APPENDIX E

URS Greiner Field Sampling

**FIELD SAMPLE PLAN ALTERATIONS
FOR THE
BUNKER HILL FACILITY/COEUR D'ALENE BASIN PROJECT
SHOSHONE COUNTY, IDAHO**

February 1998

Figure 1
Surface Water Stations
on the North Fork of the
Coeur d'Alene River

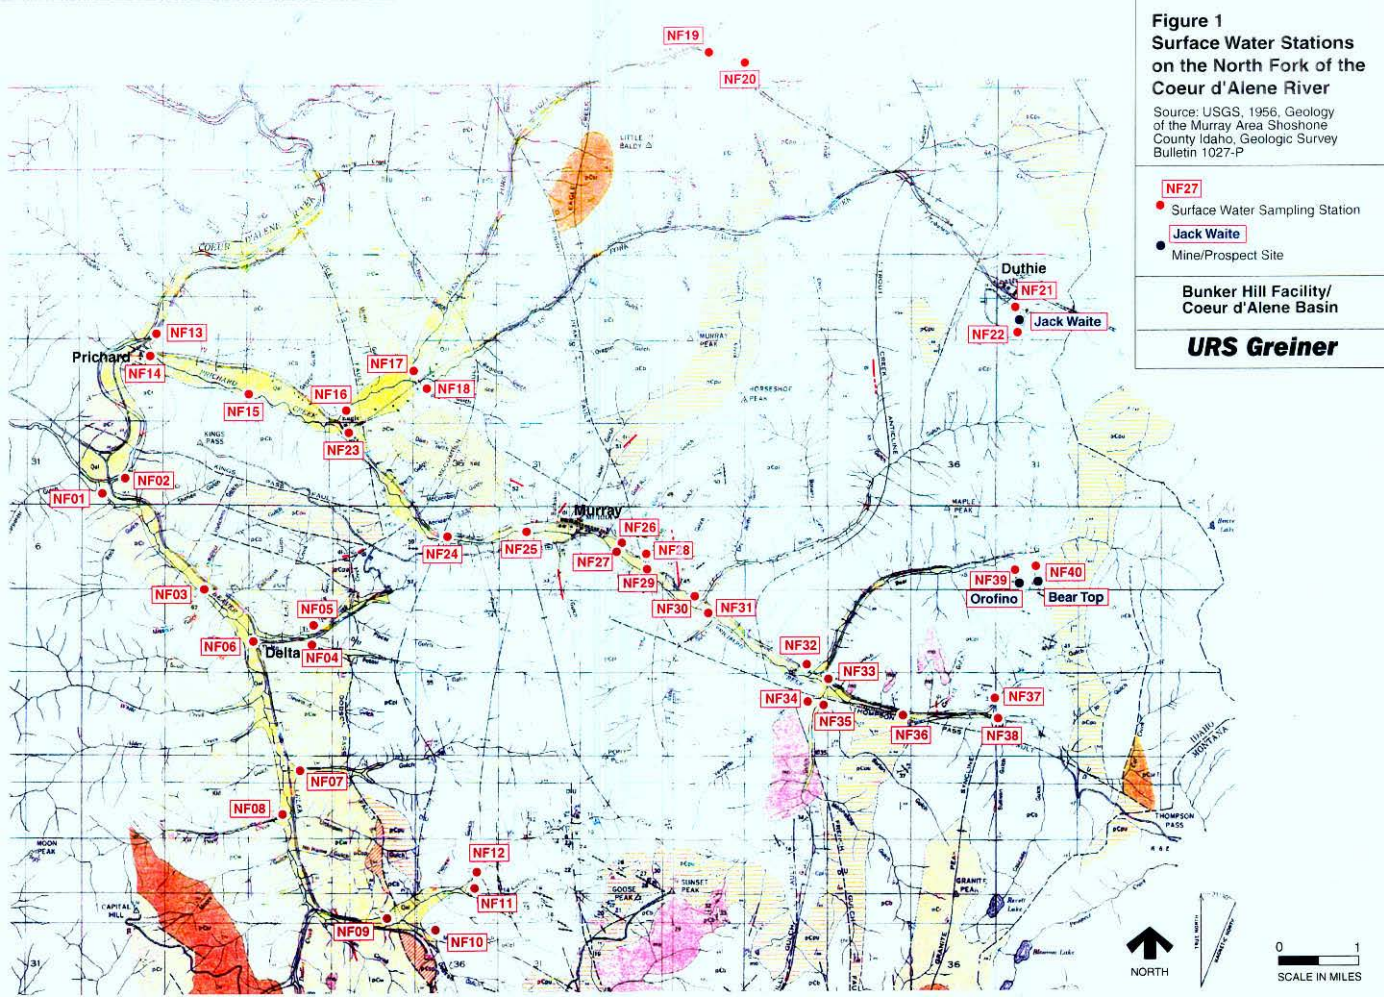
Original plan: The original plan indicated that 75 samples would be collected within the North Fork of the Coeur d'Alene River (NFCDR) basin. Specific locations for these samples were not provided (refer to page 9 of the workplan).

Alteration: Detailed descriptions are provided in Table 1 for 47 sampling locations within the NFCDR basin. Additionally, these locations are shown in Figure 1.

Figure 1
Golconda Mine Site Sample Location Map

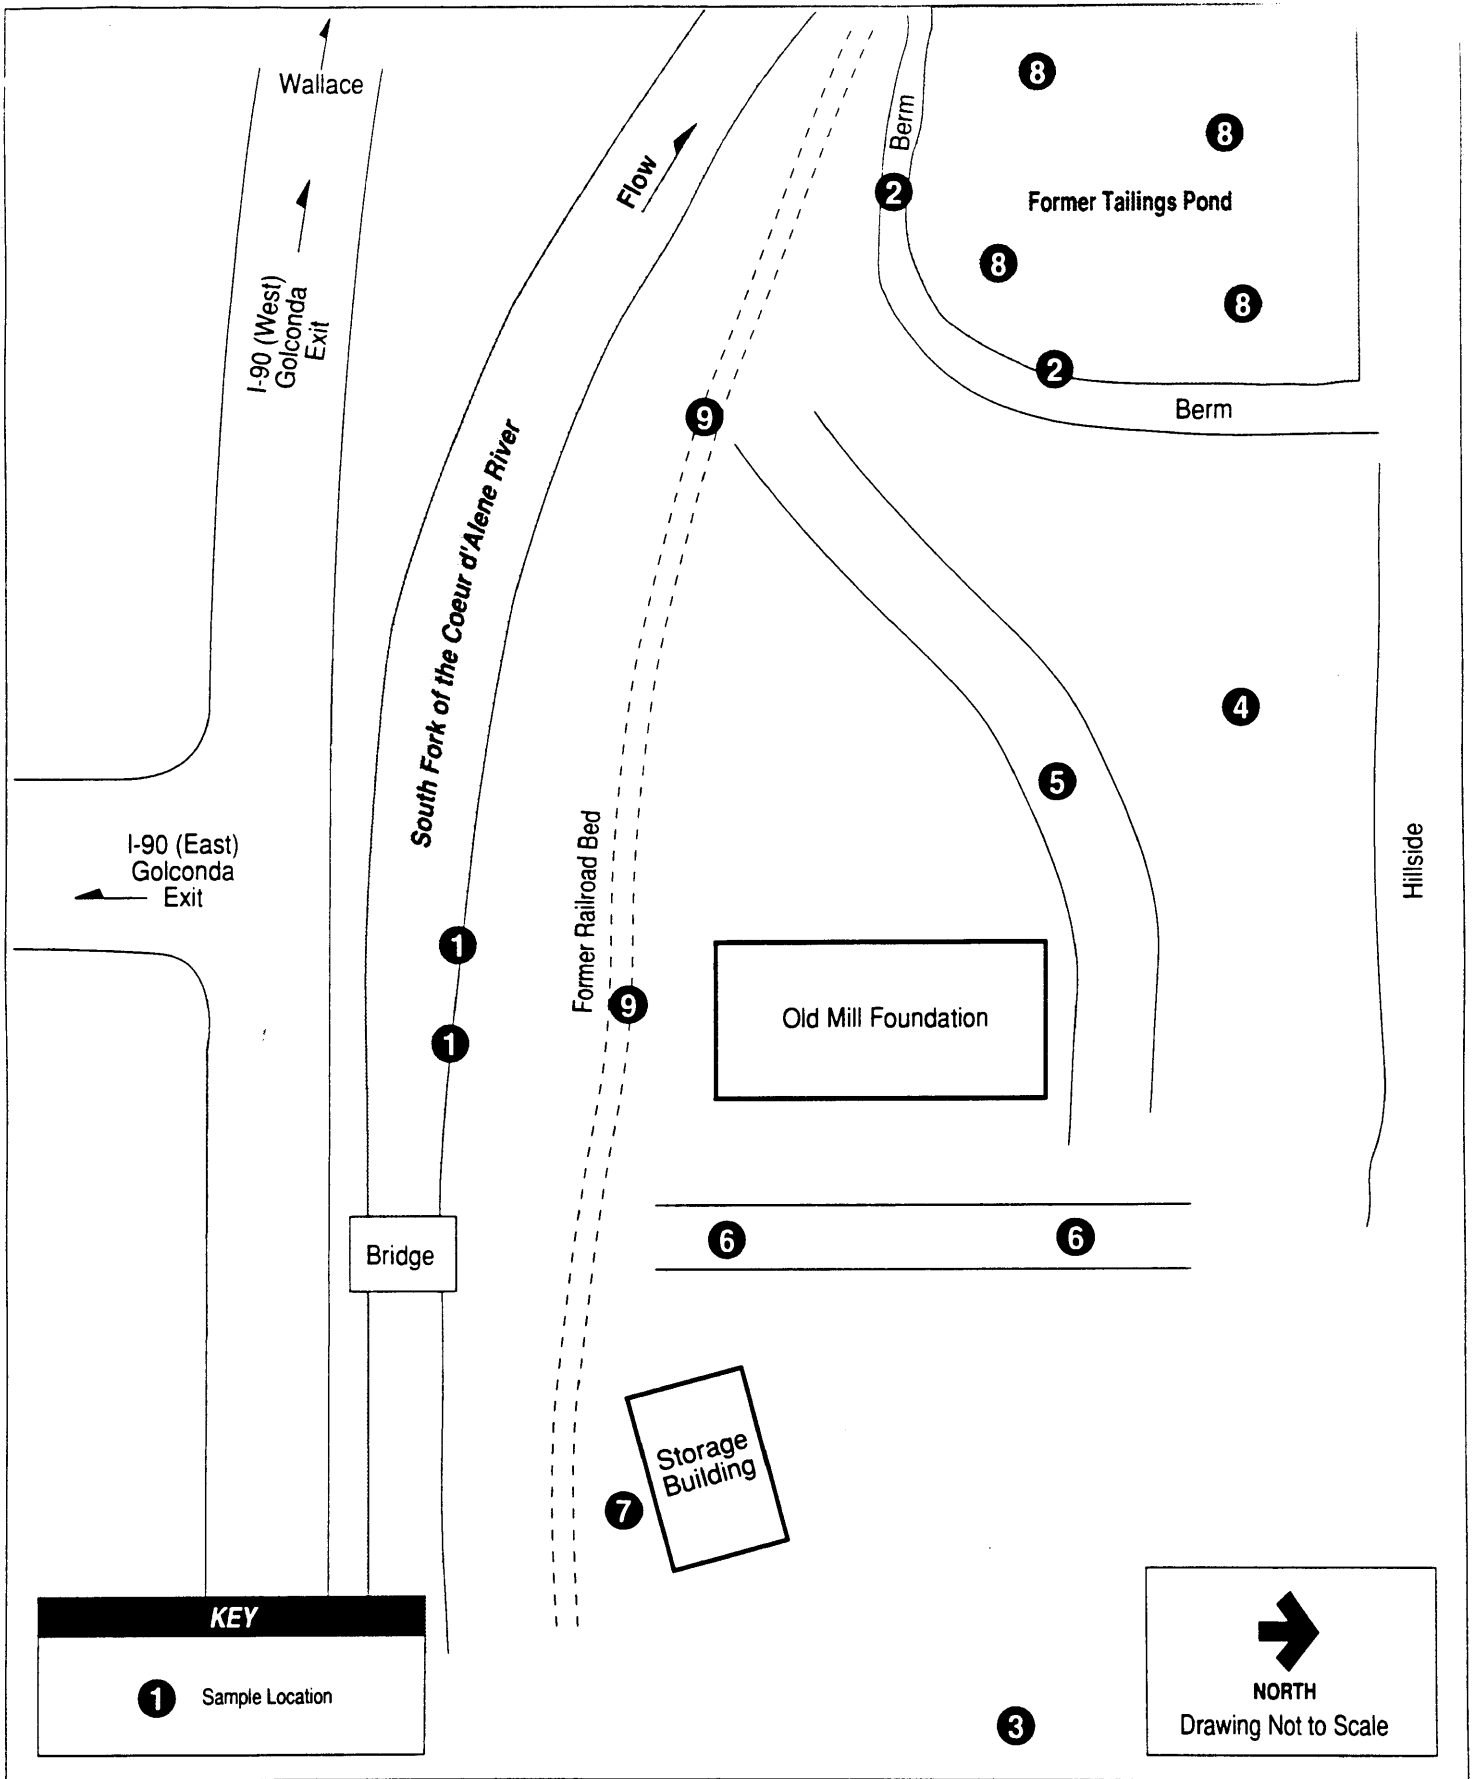
Original plan: Sampling activities at the Golconda Mine site were not identified in the original field sampling plan or in the first field sampling plan alteration.

Alteration: Soil samples were collected from 9 areas at the Golconda Mine site. Figure 1 shows a general sketch of the Golconda Mine site and the locations where samples were collected, some were composite sampling sites. The sample stations are identified on the figure as listed in Table 6.
